CO87 – Appalachian Mountain Advocates (on behalf of 15 groups)

ATLANTIC COAST PIPELINE, LLC
DOMINION TRANSMISSION, INC

Docket Nos. CP15-554-000,
CP15-554-001, CP15-555-000

COMMENTS ON THE DRAFT ENVIRONMENTAL IMPACT STATEMENT
FOR THE PROPOSED ATLANTIC COAST PIPELINE AND SUPPLY
HEADER PROJECT

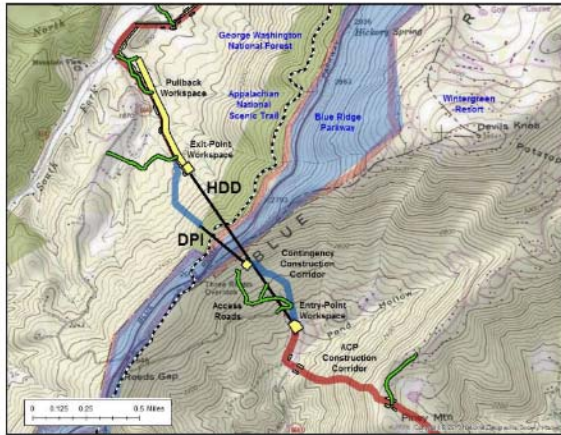
The HDD operation would involve drilling for 4,639 feet at 800 feet below the crest of the Blue Ridge.⁴⁹⁶ The contingency DPI operation would involve drilling for 1,396 feet at 200 feet below the crest.⁴⁹⁷ Both methods are commonly used for installing pipelines under rivers or other obstacles where the terrain is relatively flat and extremely hard or fractured bedrock is not encountered. The use of either method to drill for long distances through steep mountains is less

FIGURE VII(e) – Extreme pullback required for the proposed Blue Ridge HDD.

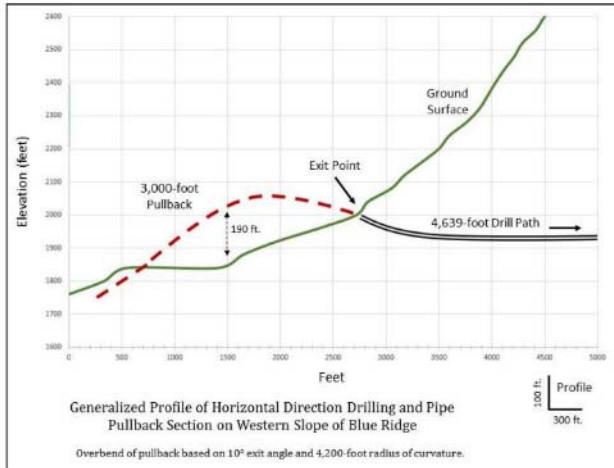
FIGURE VII(f) – Final section of pullback pipe for an HDD operation in relatively flat terrain.

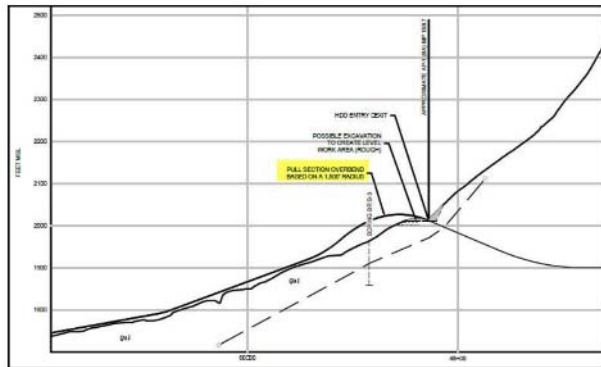
This differs substantially from the correct 4,200-foot bending radius. As indicated in the depiction, a shorter bending radius would require much less lifting of the pipe. The necessary elevation would only be about 50 feet compared to about 200 feet for the longer correct bending radius. The length of pipe suspension would also be much less.

FIGURE VII(i) – Recommended exit-side and pullback pipe fabrication workspace.

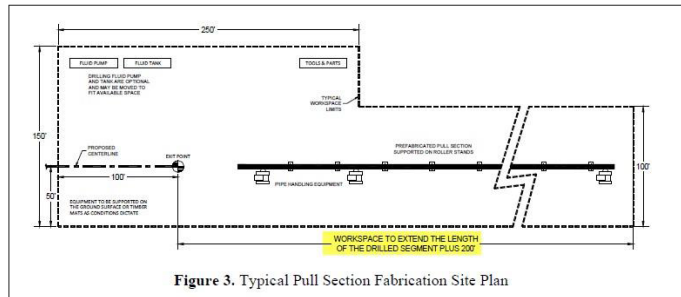
The HDD design report prepared for Atlantic by J.D. Hair & Associates, Inc. includes the following statement on pullback workspace requirements: “It is preferable to have workspace aligned with the drilled segment extending back from the exit point the length of the pull section plus approximately 200 feet. This will allow the pull section to be prefabricated in one continuous length prior to installation. If space is not available, the pull section may be fabricated in two or more sections which are welded together during installation. It should be noted that delays associated with joining multiple pipe strings during pullback can increase the risk of the pipe becoming stuck in the hole. . . . A typical pull section fabrication site plan is shown in Figure 3 [see **Figure VII(i)**]. Where possible, we recommend obtaining workspaces of similar dimensions to accommodate HDD pipe side operations on the ACP Project.”⁵¹⁶

FIGURE VII(k) – Locations of subsurface borings and geophysical surveys conducted for the proposed Blue Ridge HDD crossing. From Geotechnical Site Investigation Report for Atlantic Coast Pipeline Horizontal Directionally Drilled Crossing, Blue Ridge Parkway, Segment AP-1

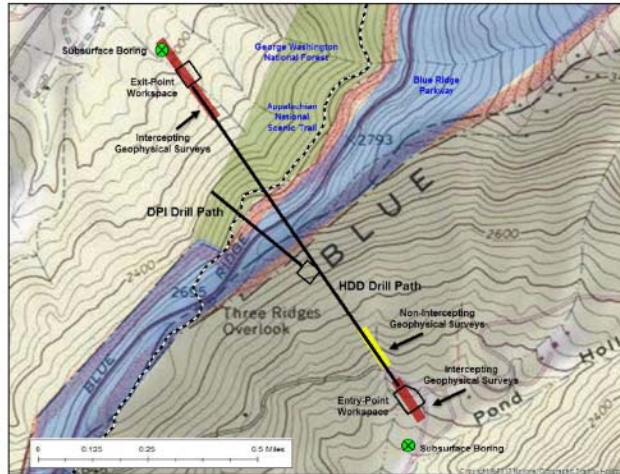
Commission by Atlantic, only two subsurface borings were completed for the proposed HDD, and both were at a lower elevation than the proposed HDD drill path. The only direct physical measurement of geotechnical properties or groundwater in the HDD area was provided by these borings. There were no subsurface borings in the area of the contingency DPI. Additional investigation using geophysical survey methods was limited to areas close to the HDD entry and exit points, covering only a small part of the projected drill path. The locations of the two subsurface borings and other geophysical surveys for the HDD are indicated in **Figure VII(k)**.

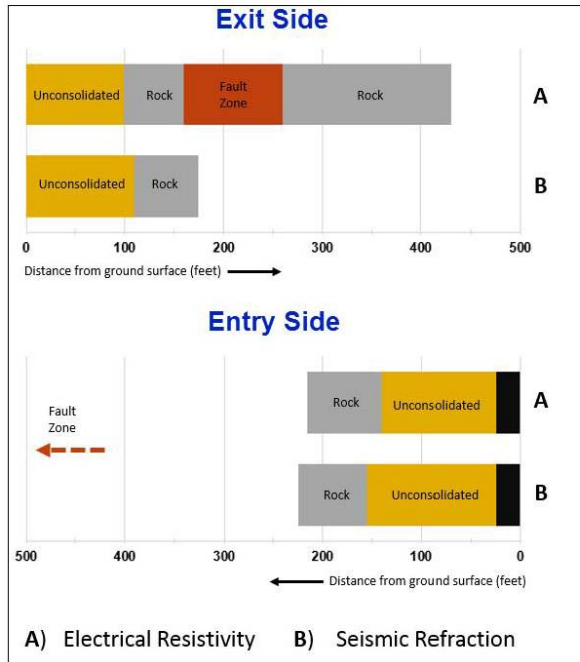
In fact, the geophysical services company that conducted and interpreted the surveys raised questions concerning the reliability of even its limited findings,
